Dear review team,

Dear MTD team,

Requirement on the MTD Timing resolution value

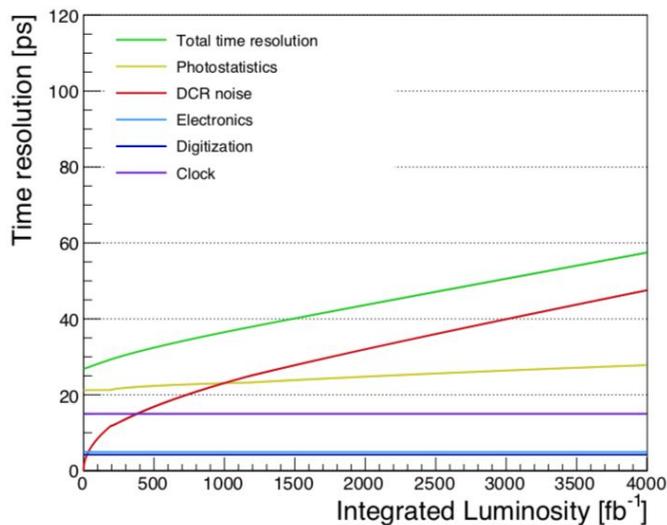
4.3. Does the simulation that demonstrates the conceptual design is sufficient include effects from the full system, including the module resolution, jitter in clock distribution all the way through the chain from TTC all the way to the FE ASIC, etc.?

BTL Timing Resolution Breakdown -- **all are included in the simulation:**

CMS clock distribution	15 ps
Digitization	6 ps
Electronics	7 ps
Photo-statistics	25 – 35 ps
Noise (SiPM dark counts)	negligible at startup, 50 ps after 4 000 fb ⁻¹

These values are evolved in terms of integrated luminosity as in the plot that follows:

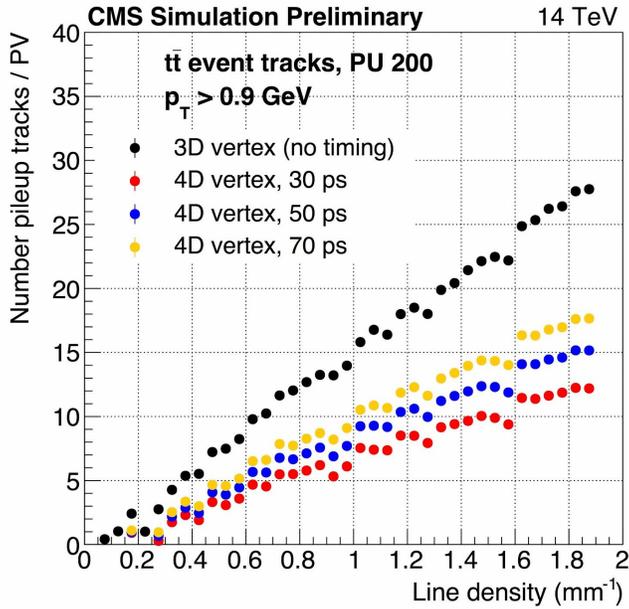
4.4. During running time the performance of the detector will deteriorate due to increase effect of radiation. This looks to be happening in the whole BLT region already at 2000/fb while for the ETL looks to be concentrated at the highest eta regions. What is

the implication on physics? Is the degradation of other parts of the full system included in the simulation? In other words, what is the impact on physics if you cannot reach < 40 ps but you instead satisfy < 60 ps?

If only 60ps is achieved system wide from beginning of life then the benefit of MTD in pileup rejection remains but is reduced by a factor of 50% compared to the projections shown in the MTD TDR which are for 40ps. This follows directly from the degradation in the amount of pileup tracks rejected from the primary vertex, as shown below.

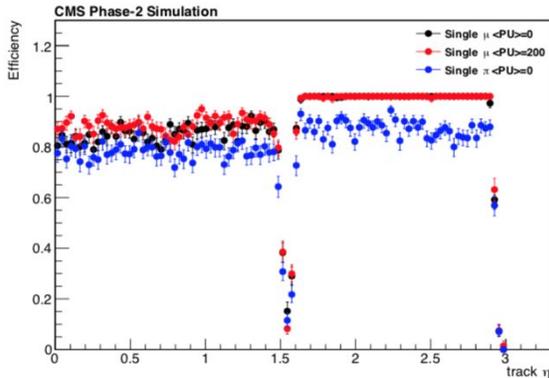
4.5. Present to us the MTD coverage in the BTL and ETL regions. This do not look to be 100% but more 85% or less. Have been these acceptance values folded in the evaluation of the reconstructed plot in the TDR?

This efficiency map (for pions) is used as input to the fast simulation of the MTD from which our high level physics results are derived.

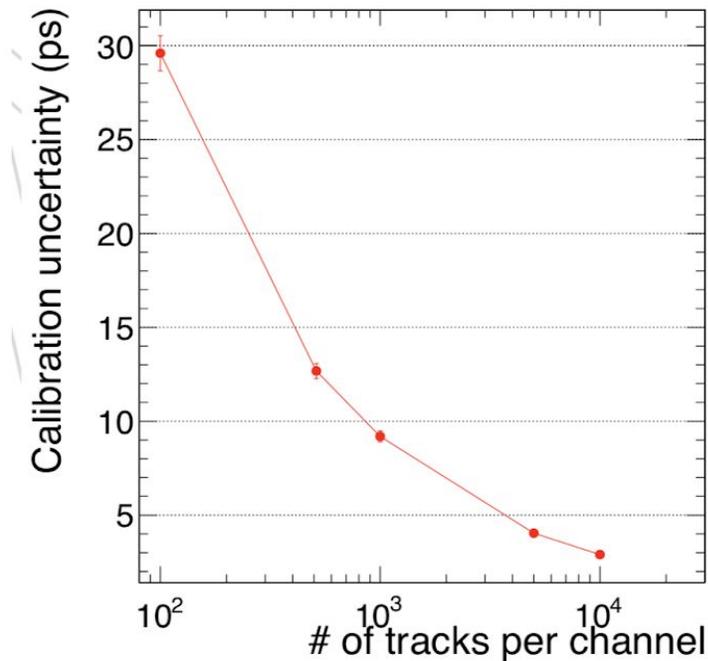
6.2 Is there a physics process that can constitute a simple calibration IN-SITU of such offsets? 10 ps time differences correspond to 1.5 mm cable differences or delay in electronics components.

A similar strategy will be deployed for MTD. The time offsets of the MTD channels can be inter-calibrated using all the tracks collected by the CMS high level trigger. The distribution of the reconstructed time at the vertex — i.e. after TOF correction — of these tracks has an RMS spread of approximately 200 ps, primarily determined by the time spread of the luminous region, as the additional spread due to the sensor resolution is marginal compared to the beam spot time spread. The mean time of this distribution over many events provide the reference calibration points.

To illustrate the method, we show results from a full simulation study for the BTL. Similar conclusions, appropriately scaled for the occupancy and channel count, apply to the ETL as well. As illustrated in this Figure, the median of the distribution provides a reference calibration point with an uncertainty of about 9 ps for 1000 tracks and of less than 3 ps for 10000 tracks, where the uncertainty is the spread between the injected time offset and the estimated time offset from the truncated mean of the distribution.

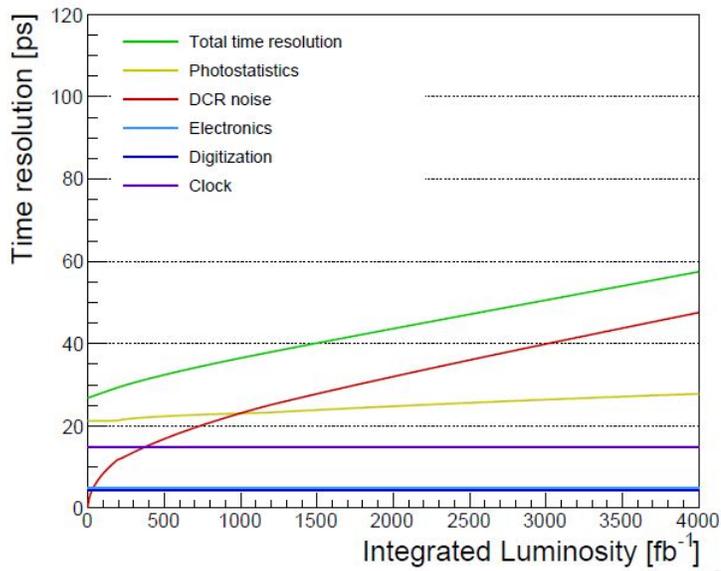
- 9.4 Effect on time resolution related to the instantaneous TID (rad/hour). From your 25 kGy after 10 years, we can derive 2.5 kGy per year i.e., 0.5 Gy/hour. Measurement of assembled BTL with MIP during irradiation should be performed before going to further. The noise induced from the scintillating tile can deteriorate the timing resolution.

We intend to do such measurements with a final spec prototype. LYSO has been irradiated to much higher doses and its radiation hardness is fully sufficient. SiPMs have been irradiated to the doses the BTL will operate at and the DCR has been measured. It is used in the calculation of the expected BTL performance vs dose. See plot below from the TDR :

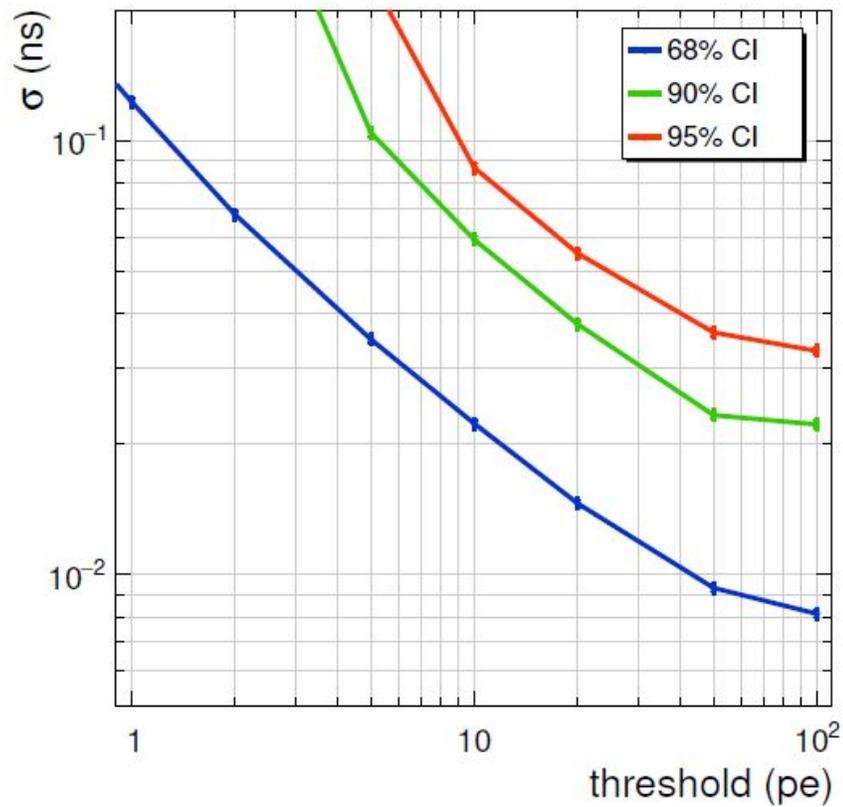
- 9.5 What is the background occupancy on the LYSO crystals? Show existing data and show where the threshold will be set.

Regarding the background from low energy pile up activity in LYSO :

The PU contribution is less than 10 ps for a threshold of 20 pe. We will operate at a higher threshold than that.

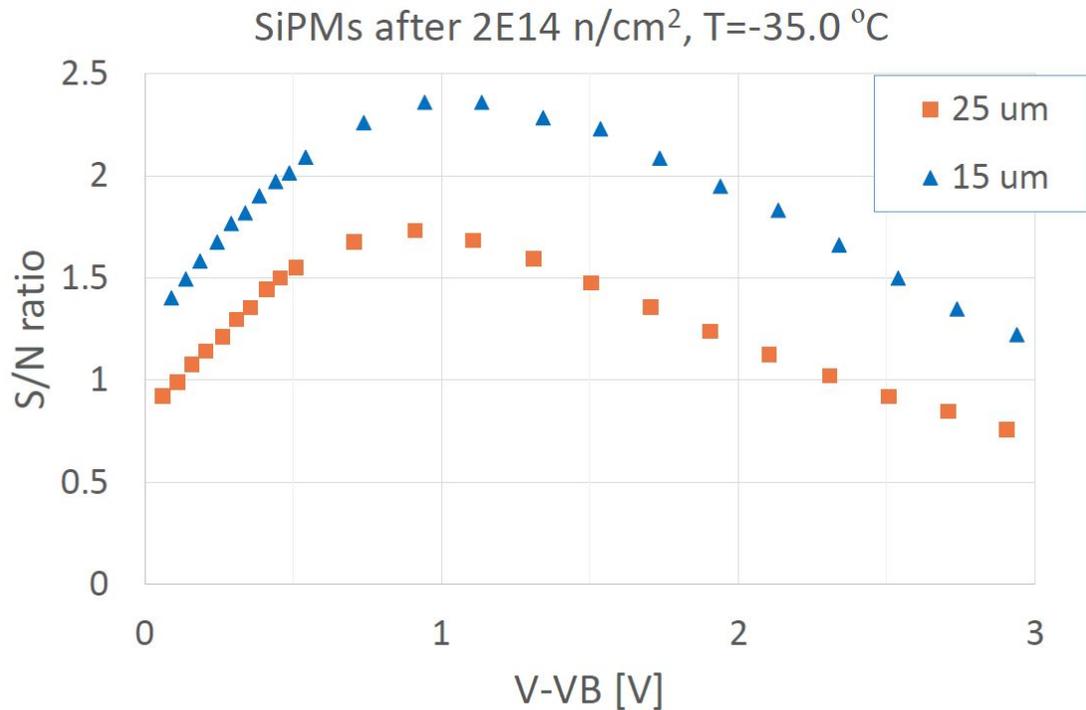
- 10.1 Pixel choice. Why 15 and not 30 μm (or 50)??. There is a compromise between dynamic range, DCR, radiation hardness and PDE. PDE suggest to go to larger pixel size. It is quite likely that 50 μm may be more radiation herd for timing applications. They have higher gain and faster rise of the PDE with voltage, hence they can operate at lower overvoltage and the DCR is a strong function of overvoltage, even stronger at lower temperatures

We compared the performance of HPK 15 μm vs 25 μm pixel size, at a few different doses up to $2E14$. The 15 μm devices had better signal/noise at lower temperature (-35 degrees for our test) and also had a better reduction of dark current as the temperature is decreased. The 25 μm devices exhibited high cell occupancy and self-heating effects for doses $> 2E13$. (Plots and a summary slide are available)

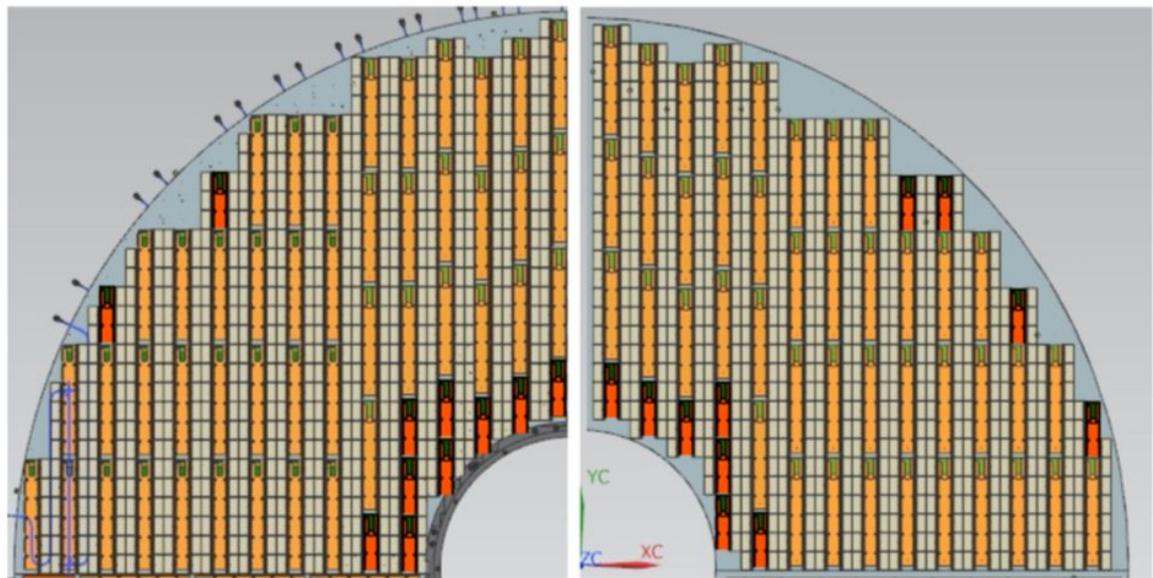
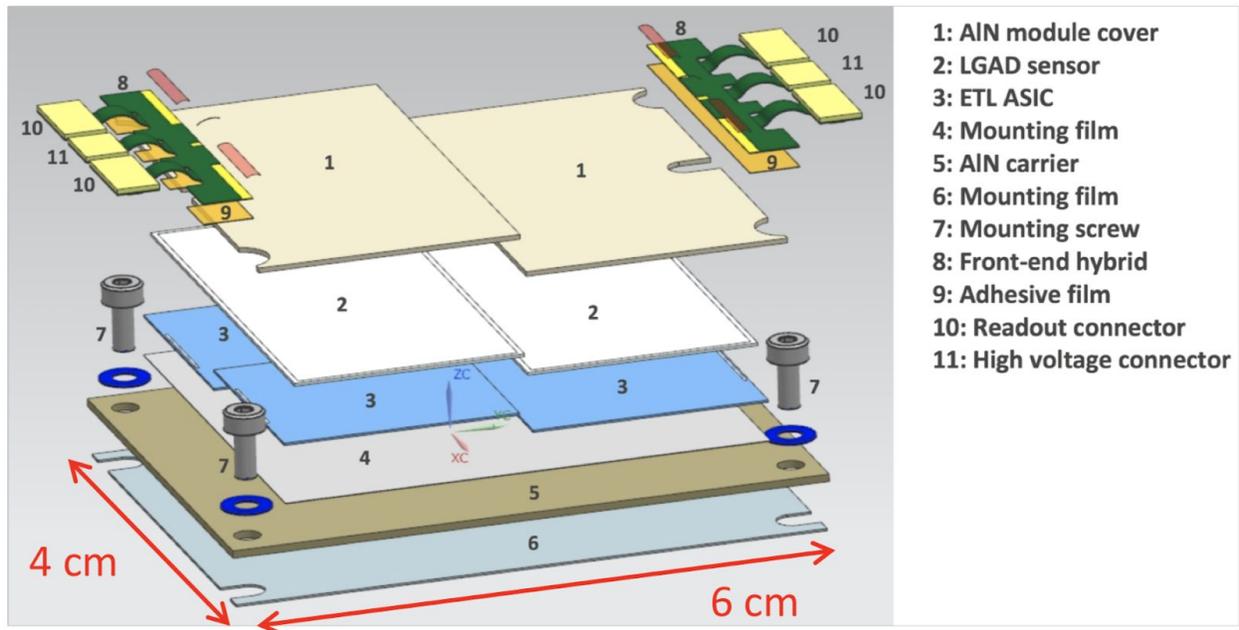
- 12.6 Does the design allow for replacement of radiation damaged inner modules without replacing the whole thing? Can you point to a few drawings?

The modules are mounted with screws and one-sided tacky film, hence we maintain the ability to replace individual modules. In order to replace a module, the Dees will be dismounted from the nose of HGCal, brought up to the lab on the surface, and laid down for ease of access to components. Service cabling that runs from outside to in between the service hybrids will be disconnected, and modules replaced and reconnected. The detailed engineering workflow for this procedure is currently being developed. We show below an image of a module that shows the screws used to tighten the modules onto wedges, The second image shows the layout of modules on wedges. Service hybrids are shown in orange, and modules are in between service hybrids.

Figure 5.24: The inverse velocity ($1/\beta$) as a function of the particle momentum, p , for BTL ($|\eta| < 1.5$) and ETL ($|\eta| > 1.6$) in HYDJET PbPb simulation at 5 TeV.

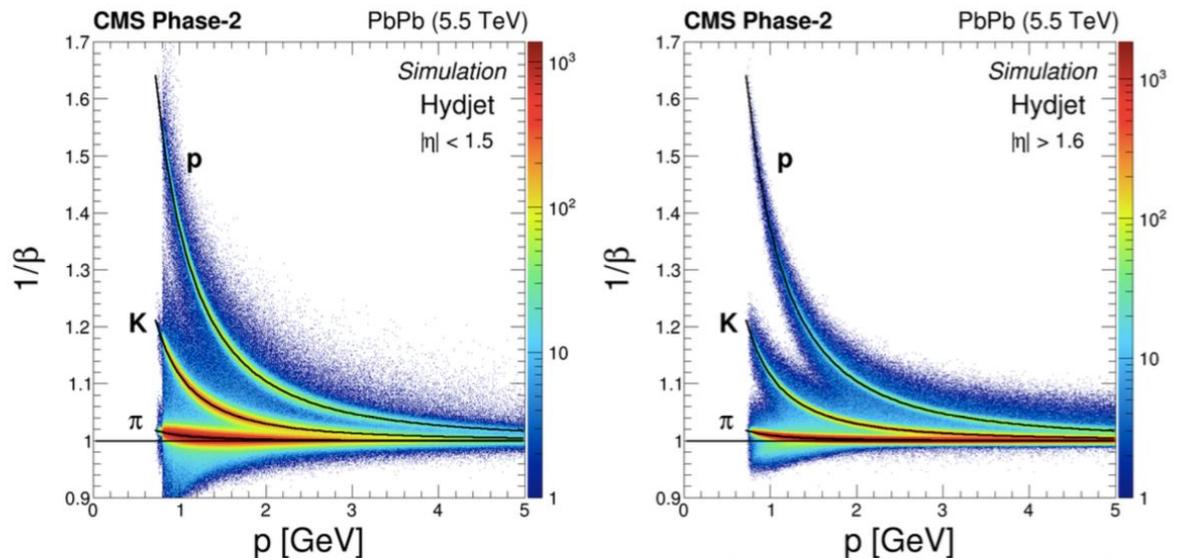
- 13.1 BTL - comments: measurement of slow moving particles. How does this work?
Time measurement is used to measure velocity. $1/\beta$ is a classic use in particle ID.

Figure 3.10: Bias voltage needed to maintain a gain of 10 as a function of fluence for sensors from HPK, CNM, and FBK.

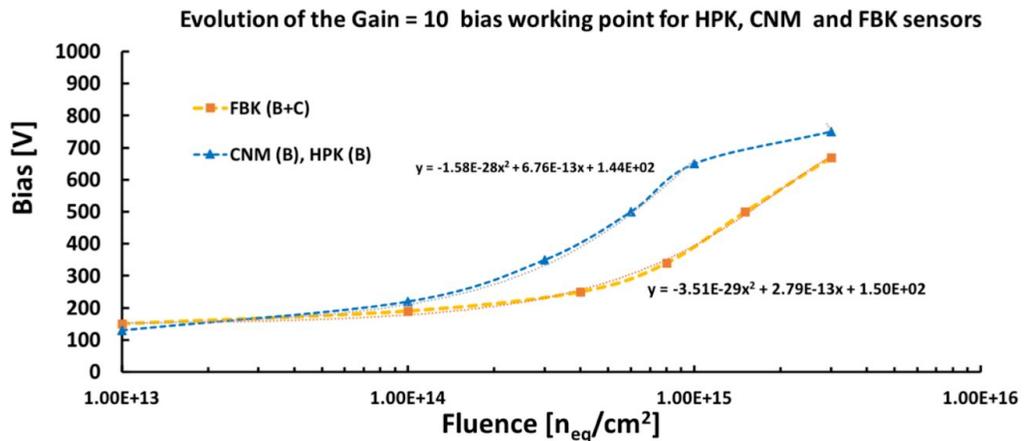
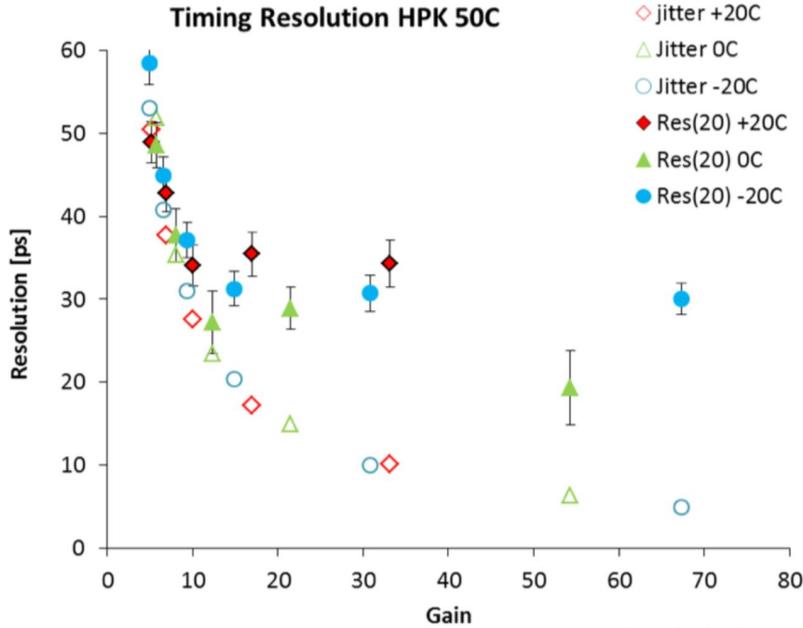
- 13.4 ETL - comments: LGAD reduced signal along the time. Solution: bias increase + preamp?

The gain of about 10 allows us to reach time resolution of 30 ps, as shown in the image below. The bias voltage can be raised in order to maintain high gain, and this dependence is shown in the second figure below.

Additionally, the ETROCs of the modules at the highest eta which are subjected to the highest fluences, can be operated at a higher power setting for the pre-amp to recover some of the degradation of the resolution.
